**WOKINGHAM
BOROUGH COUNCIL**

Full Planning Approval Consultation

Site Address: 109 Victoria Road, Wargrave, Wokingham, RG10 8AG

Proposal: Full application for the proposed erection of 8no. dwellings following demolition of the existing buildings and structures plus alterations to the existing access.

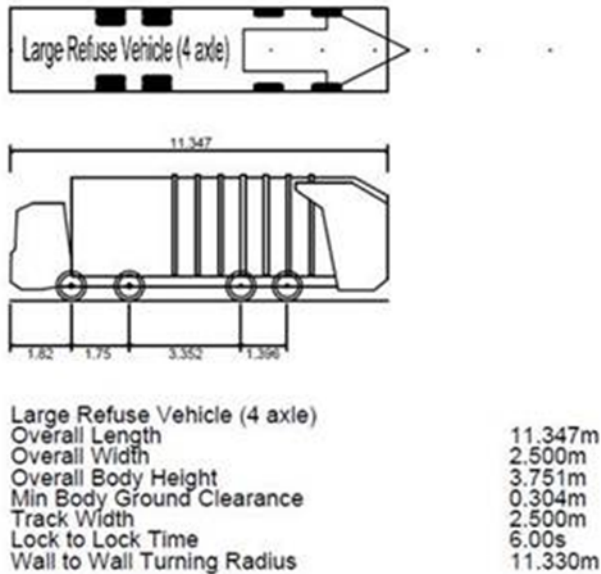
Swept path analysis for a refuse vehicle and fire tender should be reviewed to accommodate any revisions to the junction layout and shall include assessment of existing on-street parking on Victoria Road, opposite the access (see photo).

This is still required to be provided.
